United States Patent and Trademark Office

APPLICATION NO.	FILING DATE	FIRST NAMED INVENTOR	ATTORNEY DOCKET NO.	CONFIRMATION NO.	
10/644,798	08/21/2003	Philip Glen Miller	11096.105	7389	
41434 75	590 12/15/2005		EXAMINER		
PATTON BOGGS LLP 2550 M STREET NW WASHINGTON, DC 20037-1350			A, PHI DIEU TRAN		
			ART UNIT	PAPER NUMBER	
			3637

ΙΔ	pplication No.	Applicant(s)			
. Office Action Summary			MILLER ET AL.			
		10/644,798 examiner	Art Unit			
•	-					
The MAILING DATE of this com		hi D. A	3637	-		
Period for Reply	патсацоп арреа	is on the cover sheet with the co	mespondence addres	15		
A SHORTENED STATUTORY PERIO WHICHEVER IS LONGER, FROM TH - Extensions of time may be available under the provi after SIX (6) MONTHS from the mailing date of this If NO period for reply is specified above, the maximum Failure to reply within the set or extended period for Any reply received by the Office later than three moderned patent term adjustment. See 37 CFR 1.704	E MAILING DATI sions of 37 CFR 1.136(a communication. um statutory period will a reply will, by statute, cau nths after the mailing dat	E OF THIS COMMUNICATION 1). In no event, however, may a reply be tim 1) in pply and will expire

PROTECTED STEEL STRUCTURE AND METHOD OF FORMING THE SAME Filed July 30, 1932

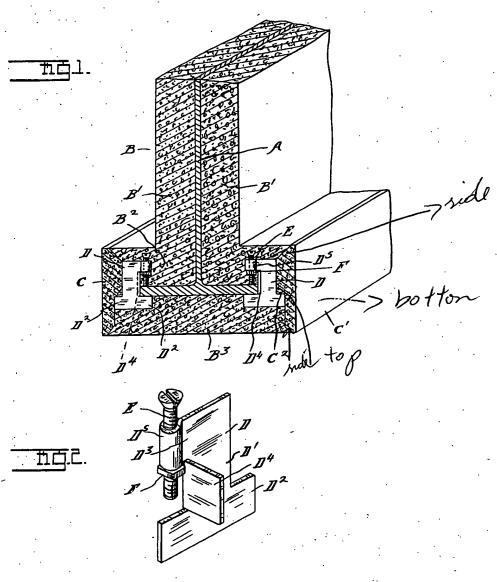
Hanna shows an apparatus comprising a precast element (C, C'), securement structure (D), the precast element including a top surface including a flat portion a bottom surface including a flat portion, a first and second side surface surfaces extending from the top surface to the bottom surface, the first side surface of the precast element being non-parallel relative to the second side surface of the element, the element including a fire proof material, the securement structure is attached to the element and projects out of the top surface of the precast element, the flat portion of the top surface of the precast element being substantially parallel to the flat portion of the bottom surface of the element, the securement structure is configured to secure the element to an I-beam (A), the securement structure including a clamp (the end of part E), the securement structure is permanently attached to the precast element, the element is configured to serve as a screed guide (inherently capable of doing so), the element is configured to serve as a stay in

place screed guide (inherently capable of doing so), the element including a chamfer (at the 45 degree angle shown), a plurality of precast elements, the fireproof material is applied between the plurality of precast element.

Hanna shows all the claimed limitations except for the material being concrete.

Hanna further discloses the material of parts C, C' being the same as material of part B'.

Hanna shows a system comprising a steel element (A), a precast element, one or more clamps (D), the one ore more clamps releasably secured the precast element to the steel element,

the precast element serving as a leave in place screed (inherently capable of doing so) so as to apply insulating material to the steel element to protect the steel element from fire, the steel element including a beam/column (A), the one or more clamps being integrated to the insulating element, the steel element including a flange, the one or more clamps releasably secured the element to the flange of the steel element, the insulating material is poured, sprayed and/or troweled to protect the steel element from fire, the precast element including a chamfer, the precast element including a top surface including a flat portion, a bottom surface including a flat portion, the one or more clamps projects out of the top surface of the precast element, the precast element including first and second side surfaces extending from the top surface to the bottom surface, the first side surface being non-parallel with the second side surface, the top surface being substantially parallel with the bottom surface, the steel element being an I-shaped cross section,

Hanna does not show the precast element and the insulating material being concrete.
